Manufacturer Product Service Bulletin

Number CW03-01

Subject: Capewell Supplied Pins and Ripcords

Broken Ripcord Pin

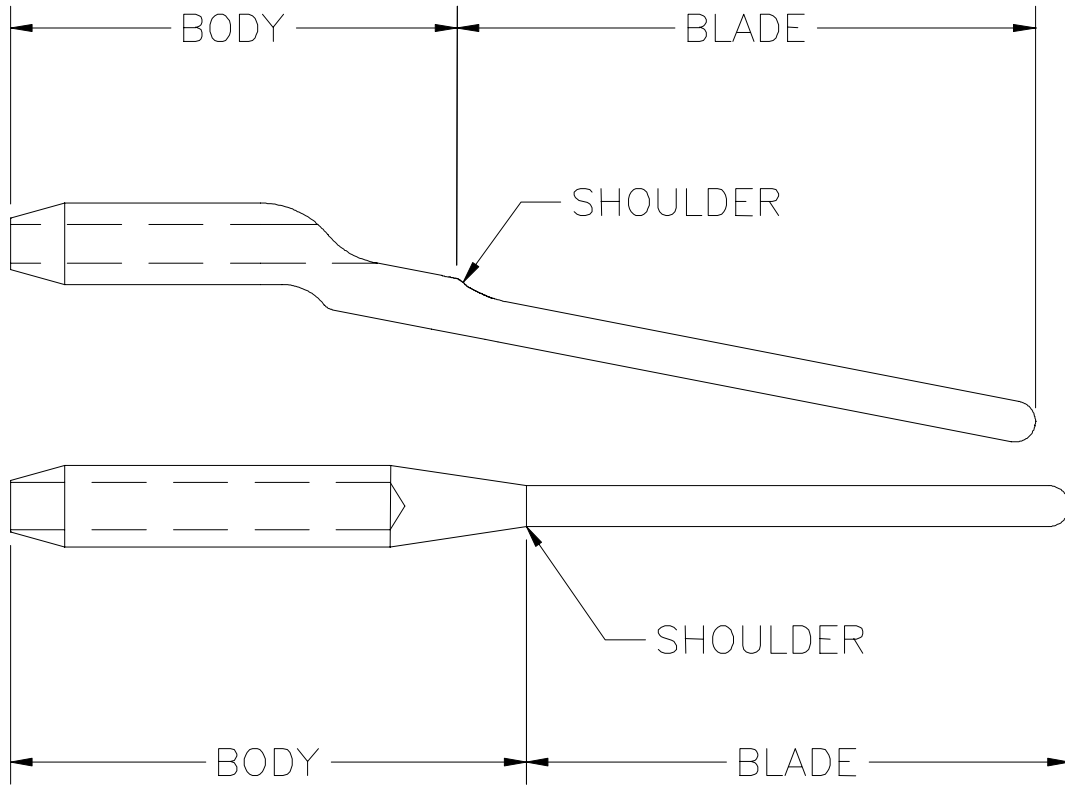
Capewell Components LLC has received (3) reports from (3) customers of (4) ripcord pins that broke. All (4) pins were reported to have broken under very low force. All (4) pins are reported to have broken on the blade section of the pin, approximately 1/8" (3 mm) from the shoulder of the pin. A broken pin is pictured below.

Affected Ripcord Pins are: MS70107 (angled), PS70107 (angled), 61C4304 (angled); 55A6480 (terminal)

WARNING: A DEFECTIVE PIN COULD CAUSE A PARACHUTE SYSTEM TO MALFUNCTION

FIGURE 1

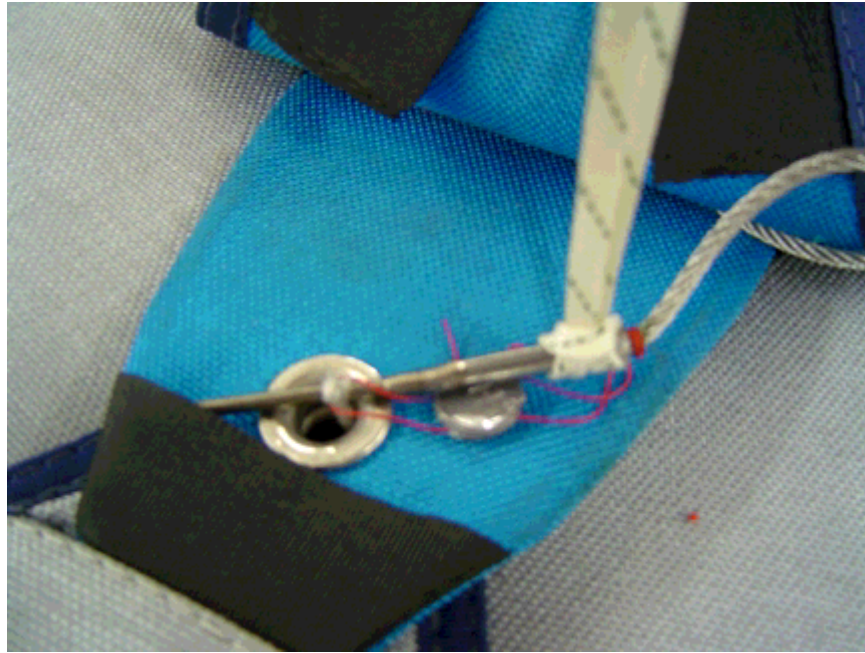
3. Take the suspension line and tie the two ends together with an overhand knot forming a loop.
4. Route the loop around the body of the pin to form a lark's head knot as close to the cable entrance end of the pin body as possible (Fig. 1).

5. Secure the other end of the loop to the spring scale.
6. Apply a load of 15 lbs. (6.8kg) straight up and 90 degrees to the axis of the pin for a period of 3 seconds and then release the load (Fig. 2). Inspect the pin for any deformation or bend. If the pin is straight, continue with step 7 below. If the pin is not straight, as visible without magnification, remove the pin/ripcord from service immediately.

FIGURE 3
All dimension in inches

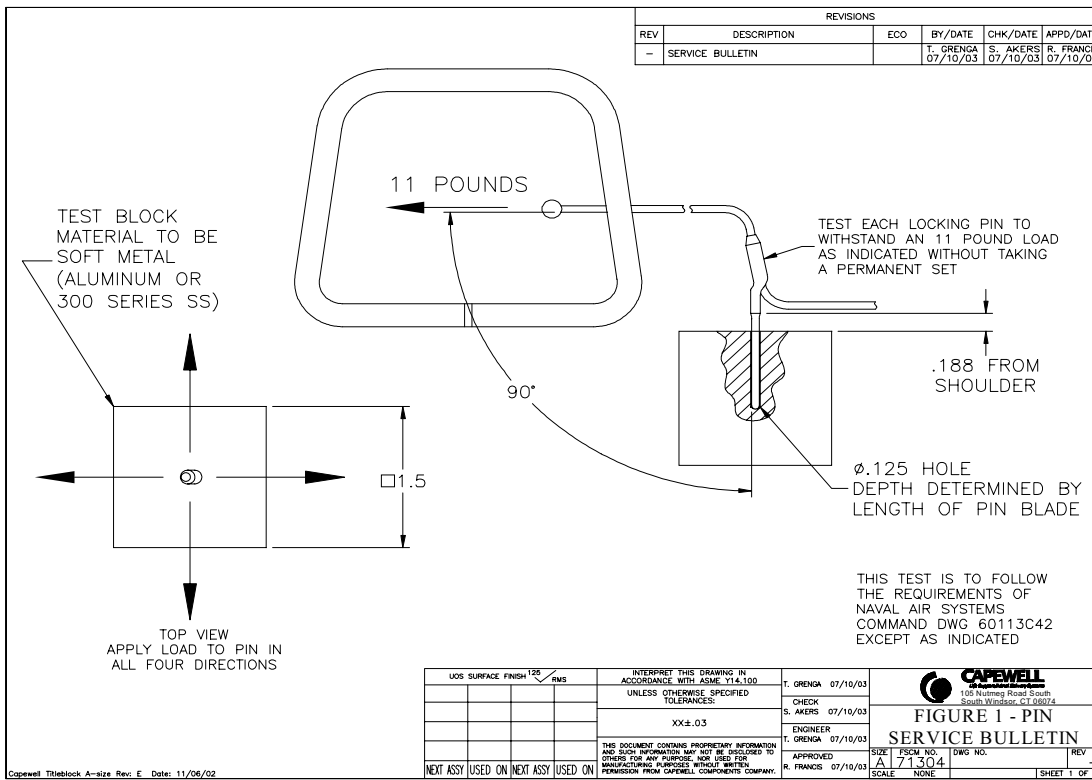
1. Place pin in test block per Figure 3 (below). NOTE: The pin block hole may be VERTICAL or HORIZONTAL
2. Apply 11 lb. force 90 degrees perpendicular to the pin blade.

3. Remove pin from block and inspect:
 - For straightness: Pins in excess of .005 (.12 mm) deformation along the blade of the pin should be removed from service.
